Spokane Park Board

Oct. 12, 2017– 1:30 p.m.

MINUTES

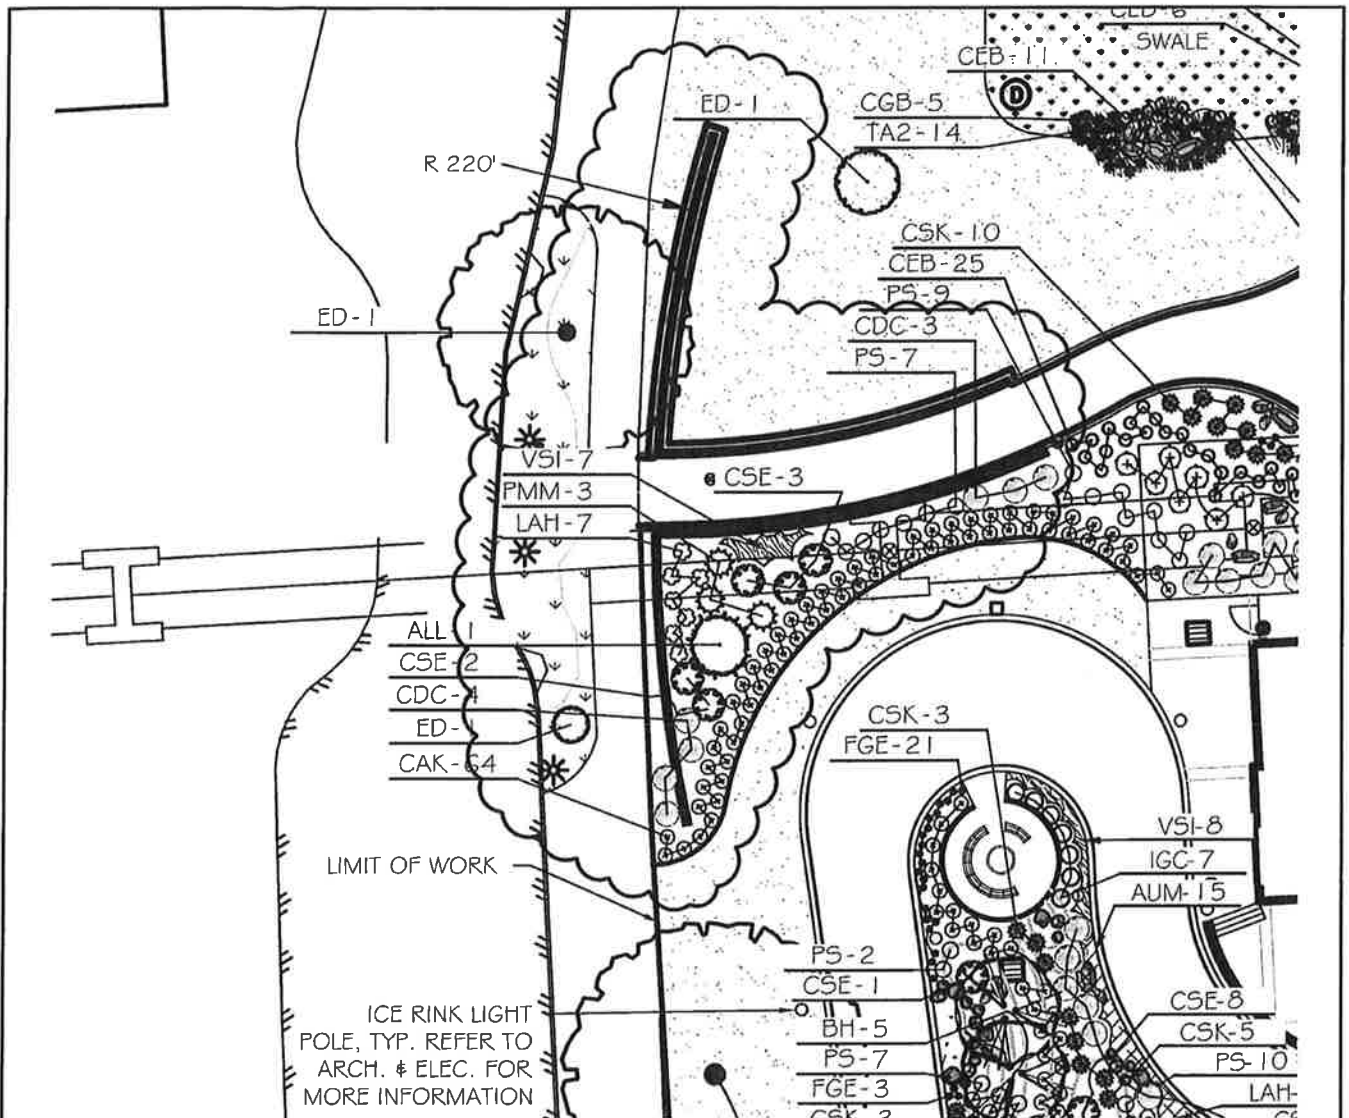
Provide and install the following per proposed ASI 12:

- 1) Reconfigured entrance at Post Street (see sheet ASI 12-1)
- 2) New Walkway (see sheet ASI 12-2)
- 3) Additional Planters at Seawall (see sheets ASI 12-3 and ASI 12-4)
- 4) Wall Irrigation Updates (see sheet ASI 12-5)
- 5) NW Lawn Irrigation Updates (see sheet ASI 12-6)
- 6) Shrub Beds at Seawall Irrigation (see sheets ASI 12-7 and ASI 12-8)
- 7) Relocated lighting to accommodate above changes (see sheets ASI 12-9 and ASI 12-10)
- 8) Exterior Ladder for Roof Access and Deletion of Interior Ladder and Roof Hatch (see sheet ASI 12-11)

Reference Sheet

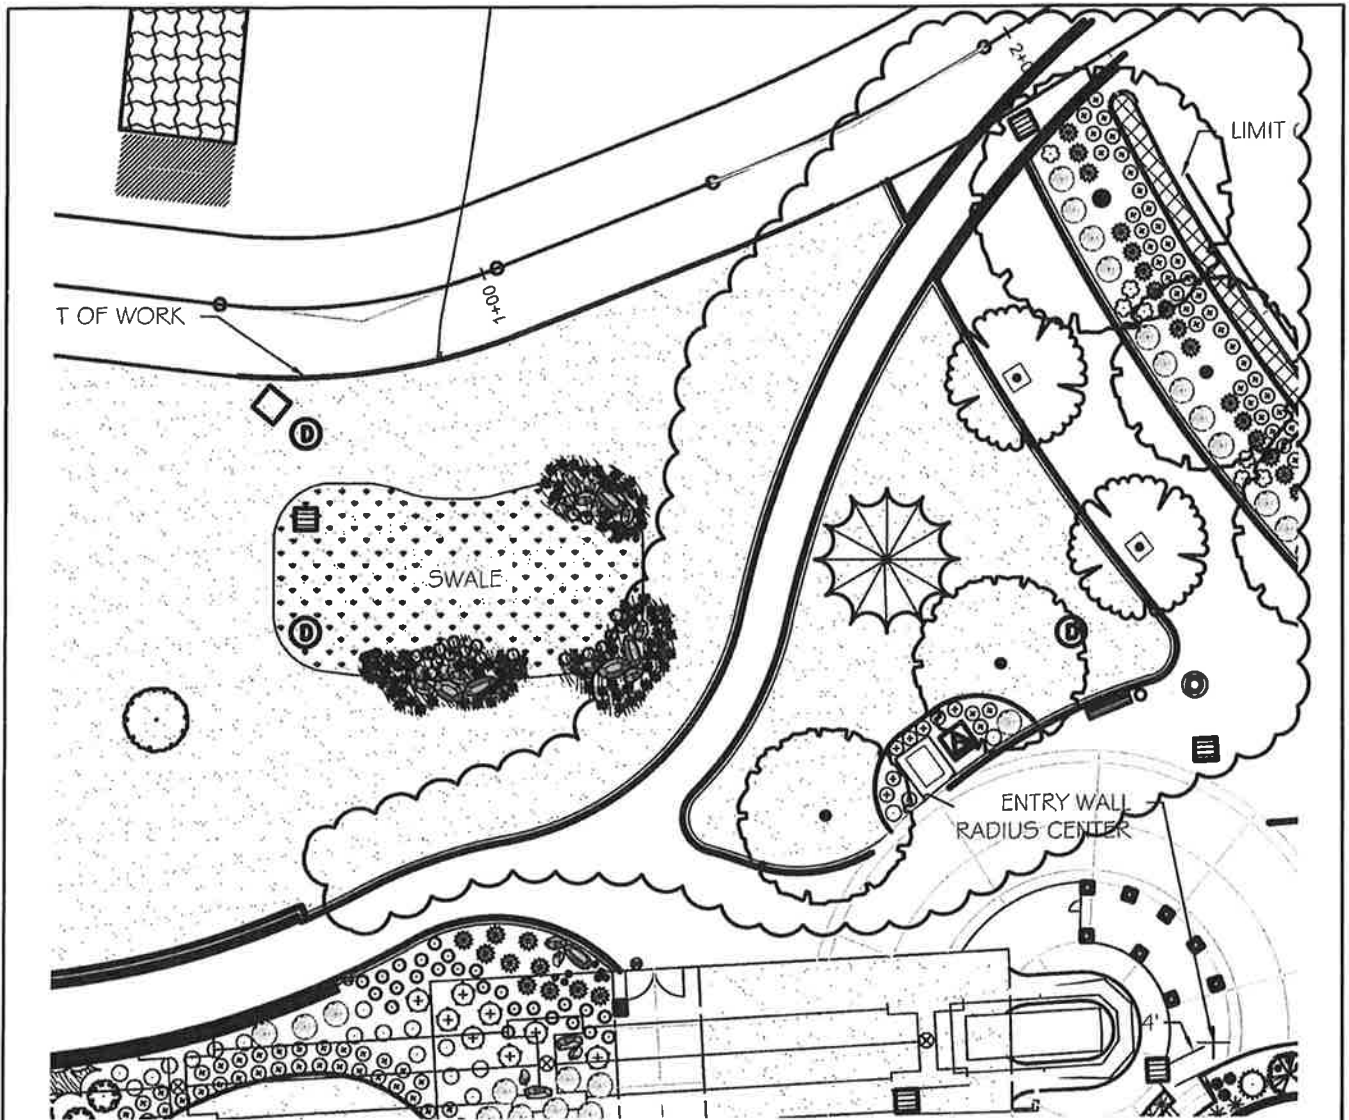
1. PROVIDE ASPHALT PATHWAY, BORDERED BY 12"x12" REINFORCED CONCRETE EDGING, THROUGH NORTHWEST LAWN, AS SHOWN. PATHWAY WIDTH SHALL BE 8' AND PROVIDE 5' RADIUS AT CORNERS, AS SHOWN.
2. LAWN AREA DECREASES BY 1,515 S.F.
3. 12"x12" REINFORCED CONCRETE EDGING INCREASES BY 292 L.F.
4. REFER TO SUBSEQUENT ASI #12 SKETCHES FOR MORE INFORMATION REGARDING PLANTING AT SEAWALL.

ASI 12-2

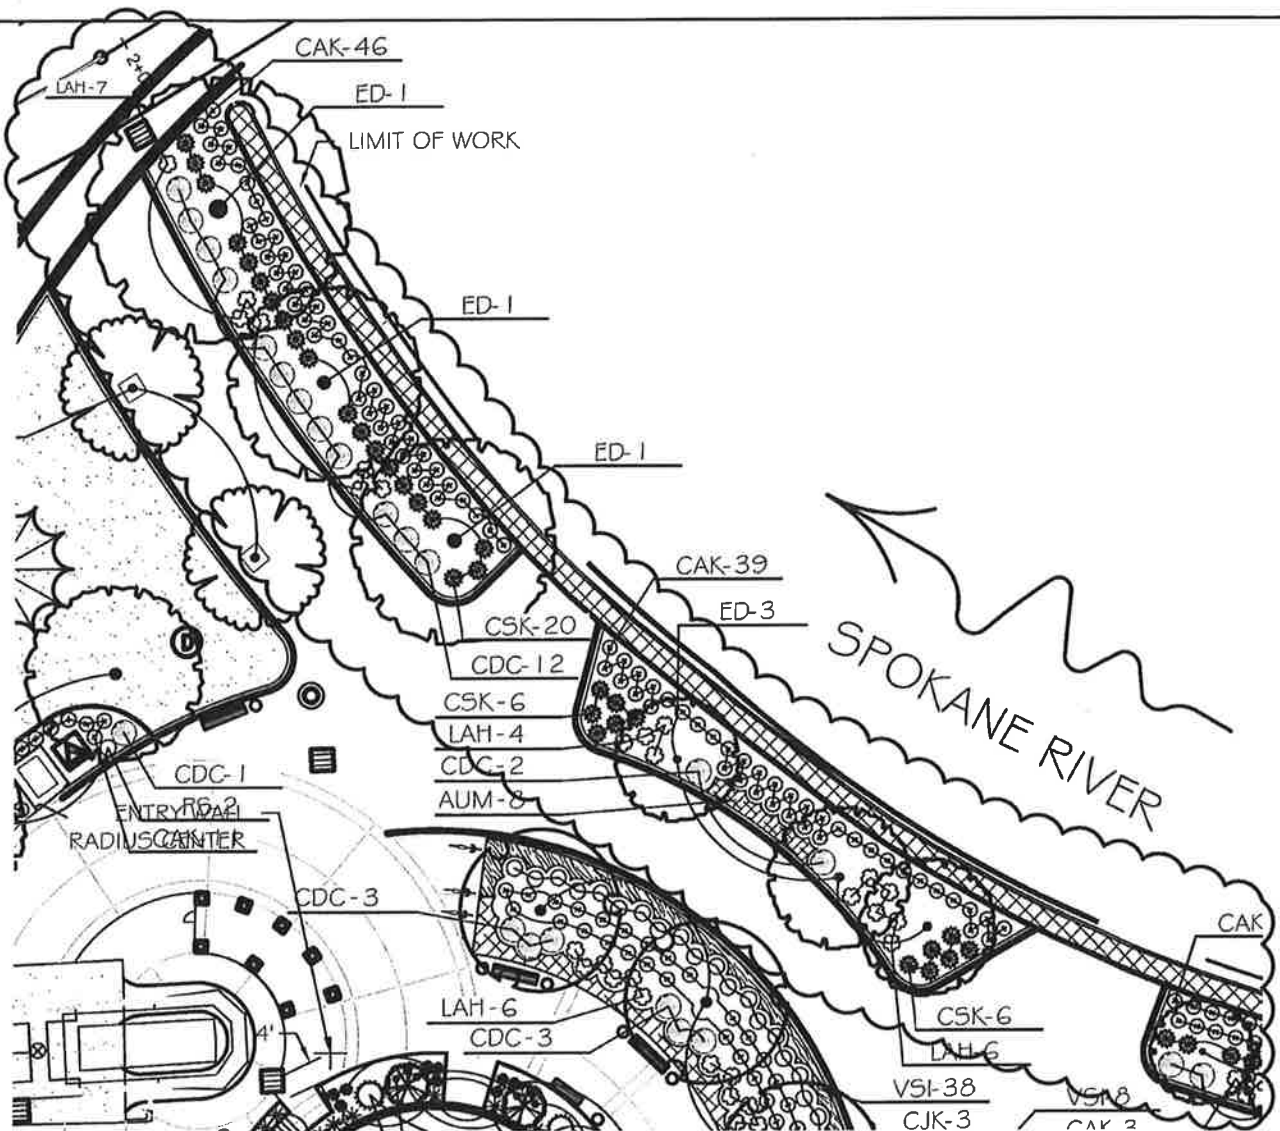
1. REMOVE 12 TREE GRATES AND REPLACE WITH AT-GRADE SHRUB BEDS, AS SHOWN.
2. SHRUB BEDS SHALL BE DEFINED BY 12"x12" REINFORCED CONCRETE EDGES, 383 L.F. PER PROPOSED PLAN.
3. REFER TO PLANT CALLOUTS FOR PROPOSED SPECIES AND QUANTITIES.
4. REFER TO SUBSEQUENT ASI #12 SKETCHES FOR MORE INFORMATION REGARDING PLANTING AT SEAWALL.

ASI 12-3

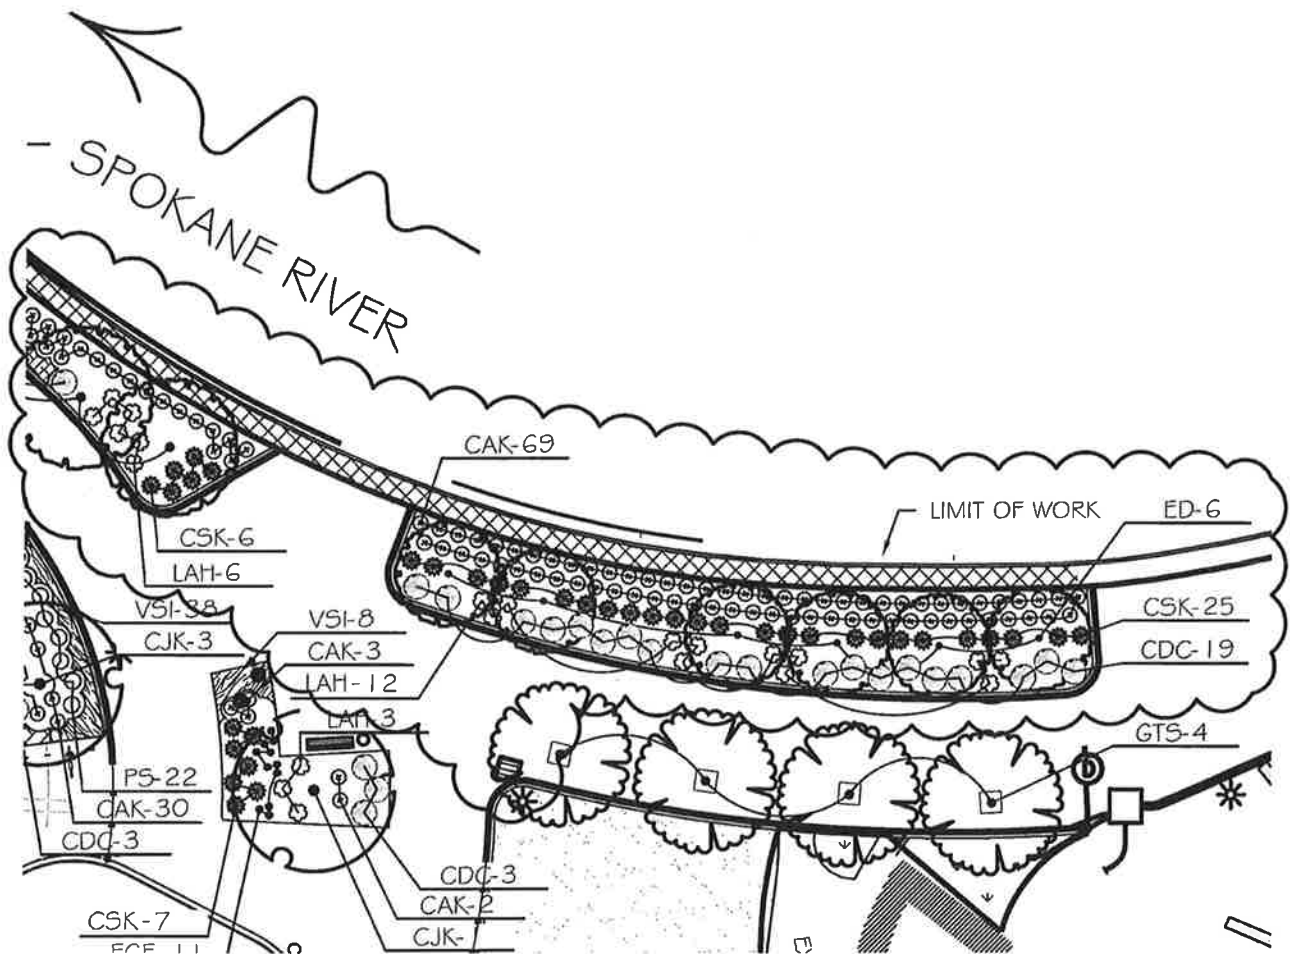
1. REFER TO PRIOR ASI #12 SKETCHES FOR MORE INFORMATION REGARDING PLANTING AT SEAWALL.
2. PROVIDE 5' RADIUS AT LAWN CORNER, AS SHOWN.
3. REFER TO PLANT CALLOUTS FOR PROPOSED SPECIES AND QUANTITIES.

ASI 12-4

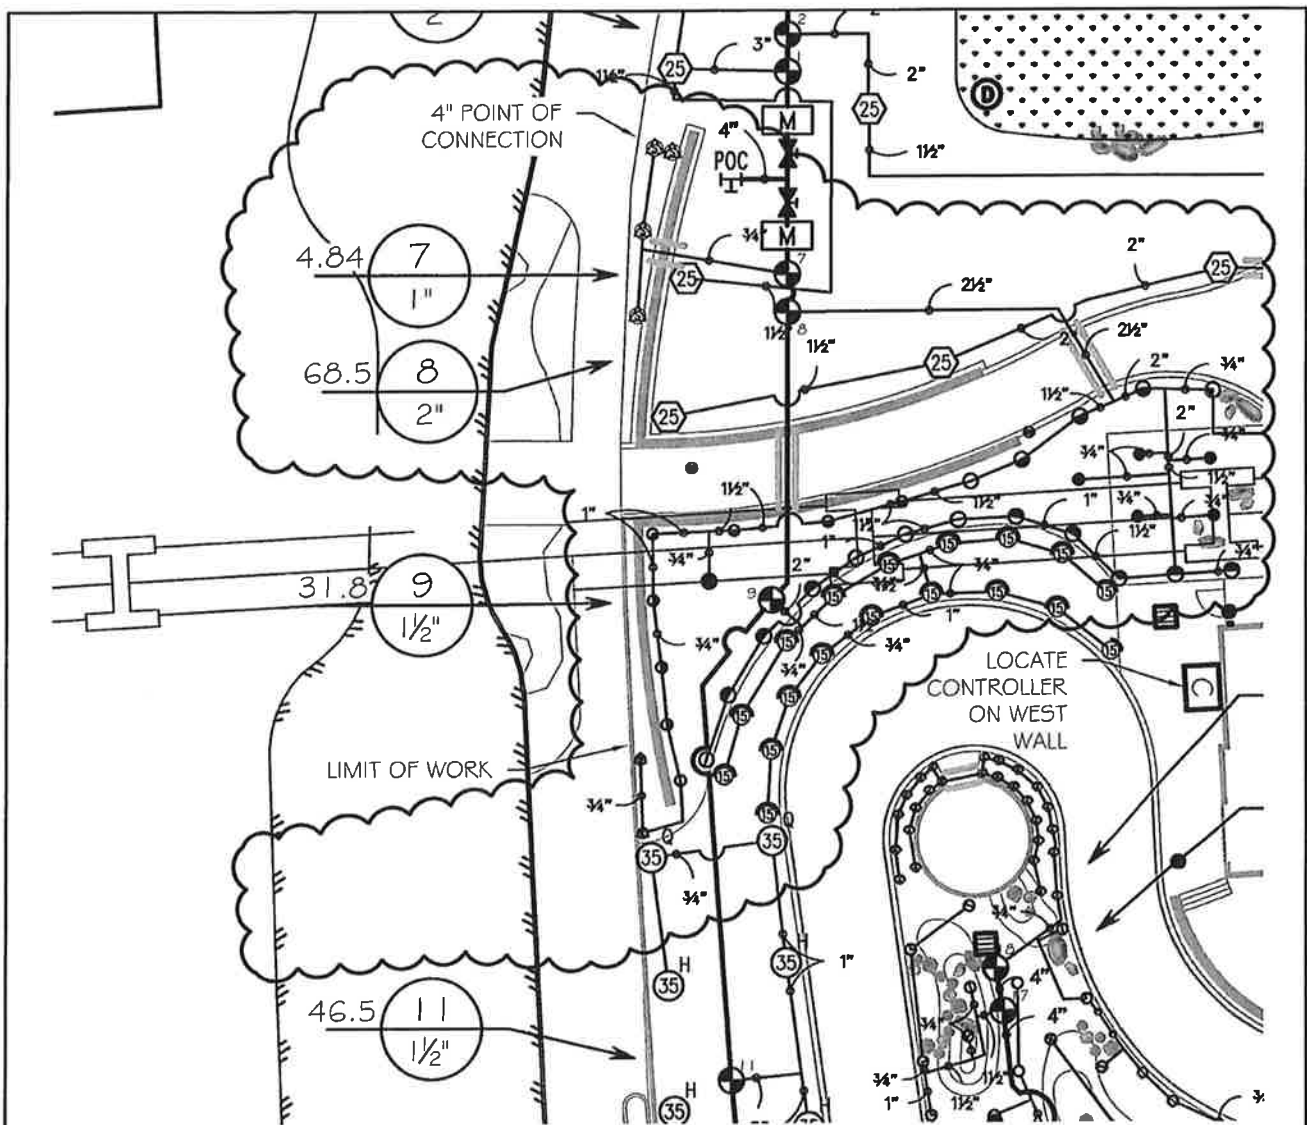
1. REMOVE ZONE #10 IN ITS ENTIRETY.
2. REVISE ZONE #8 BY SHIFTING HEADS AROUND NEW ENTRY WALL DESIGN. ADD ONE 15' FULL SPRAY AND STRIP STRAYS TO THE WEST OF THE ENTRY WALL, AS SHOWN. ZONE #8 INCREASES TO 68.5 GPM.
3. REVISE ZONE #7 TO INCLUDE SIDE STRIP SPRAYS WEST OF THE REVISED ENTRY WALL. PROVIDE SLEEVING THROUGH WALL TO REACH SPRAY ZONE AREA. ZONE #7 INCREASES TO 4.84 GMP.

ASI 12-5

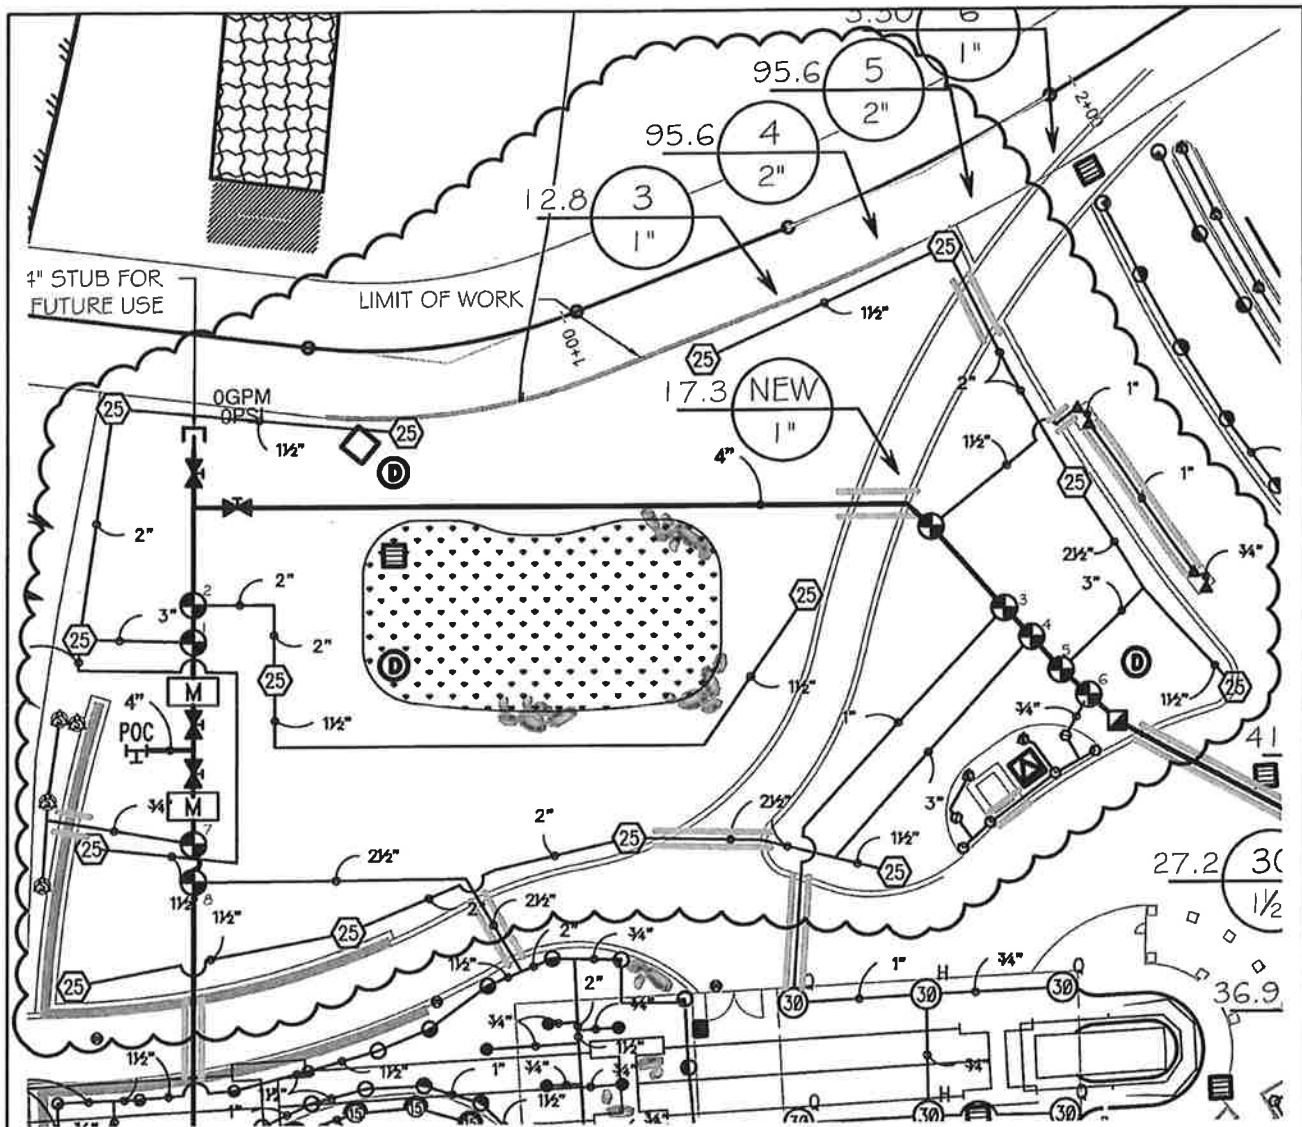
1. SHIFT 25' ROTOR OF ZONE #1 IN RESPONSE TO NEW PATHWAY, AS SHOWN. IRRIGATION WILL SPRAY OVER PATH.
2. ADJUST ROTORS TO RESPOND TO NEW ENTRY WALL DESIGN, ADD SLEEVING UNDER NEW PATHWAY (ZONES #4 AND #5), AS SHOWN.
3. ADD NEW ZONE TO IRRIGATION LOCUST TREES ON THE SOUTHERN EDGE OF LOCUST LANE, AS SHOWN.

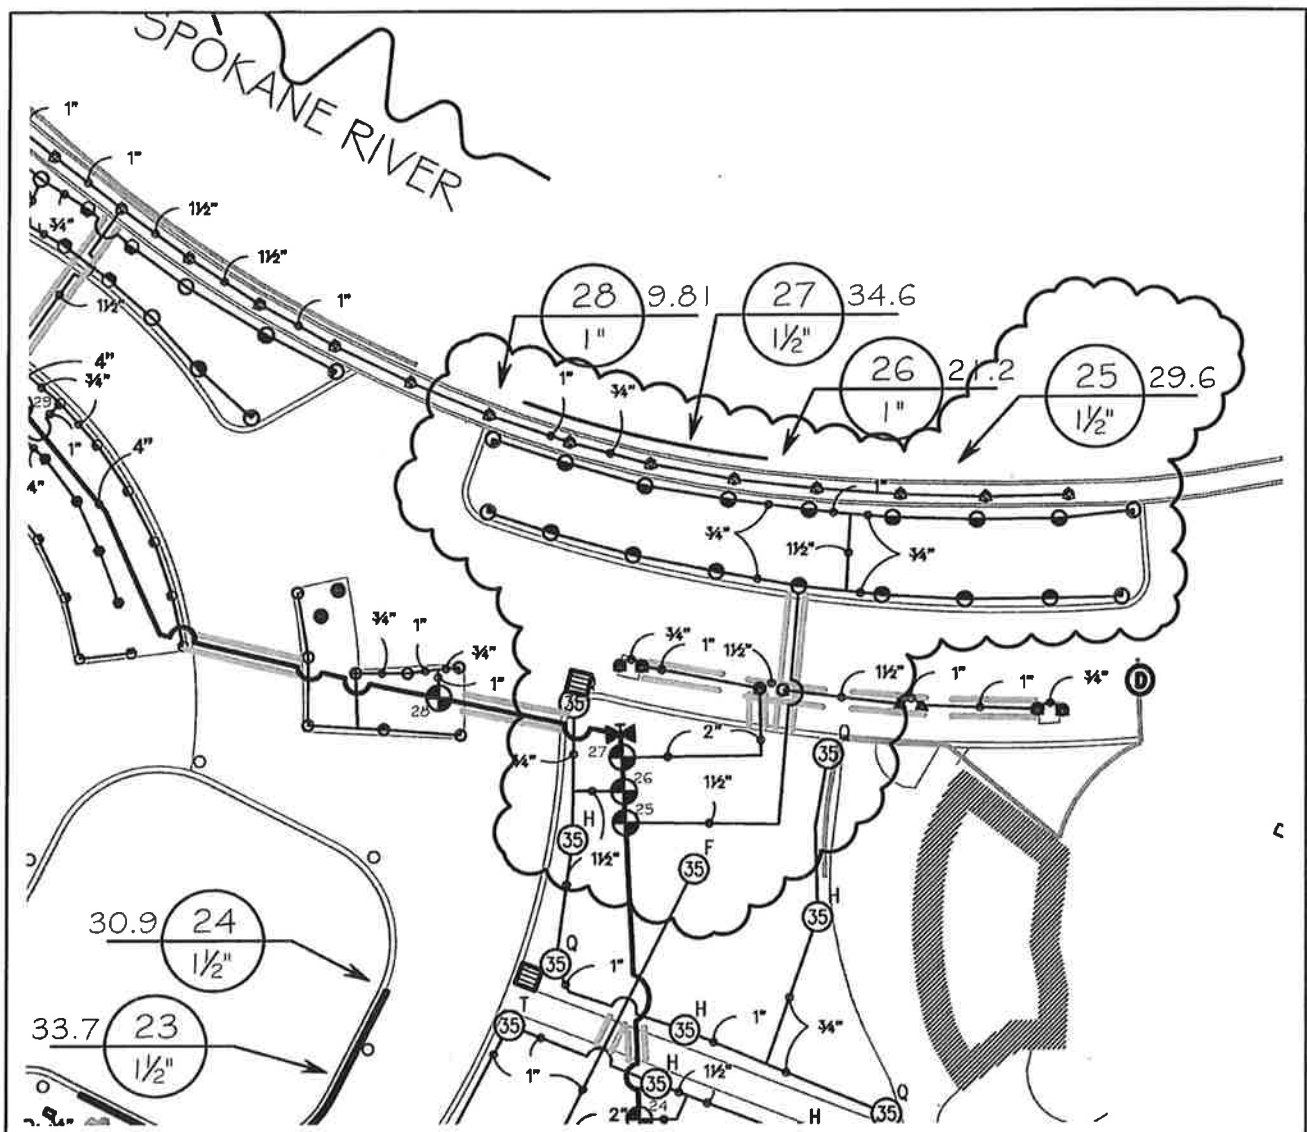
1. ZONE #25 - REPLACE BUBBLERS WITH SHRUB SPRAYS, AS SHOWN. REMOVE SLEEVING TO PRIOR-DESIGNED TREE GRATES. ZONE REDUCES TO 29.6 GPM. REPLACE 2" VALVE WITH 1.5" VALVE, AS SHOWN.

SITE ELECTRICAL PLAN

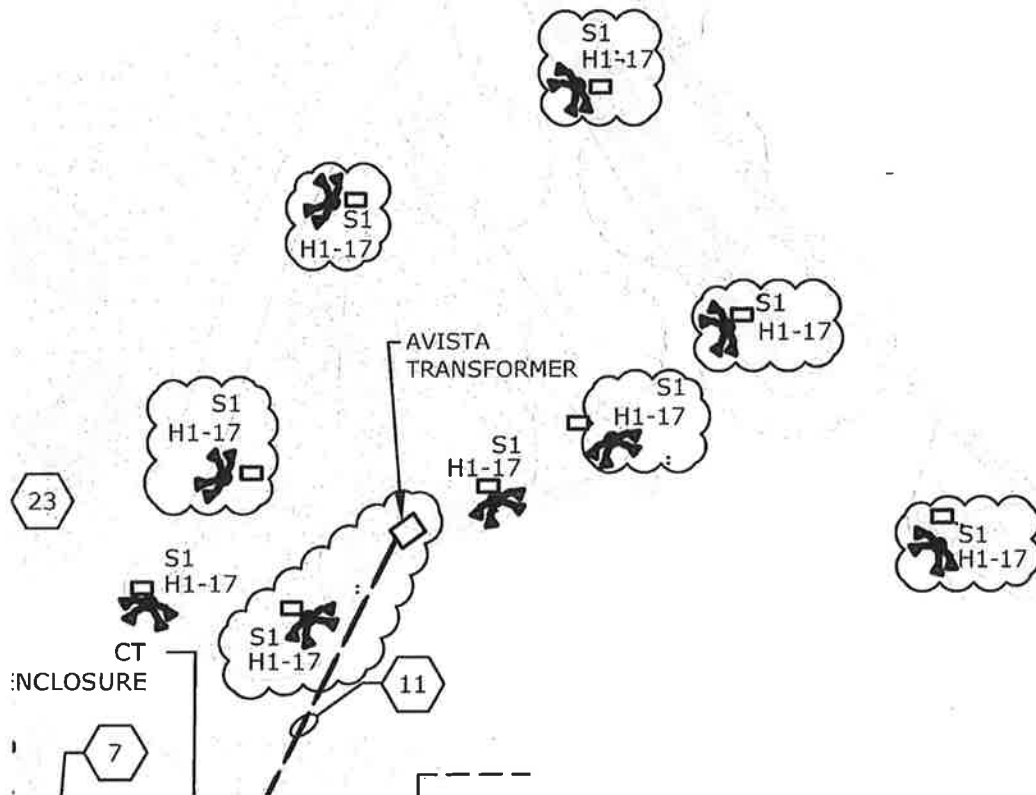
1. PROVIDE (2) ADDITIONAL TYPE S1 POLES FOR NEW PATHWAY AS SHOWN.
2. SHIFT TYPE S1 POLES TO FOLLOW PATHWAYS AS SHOWN.
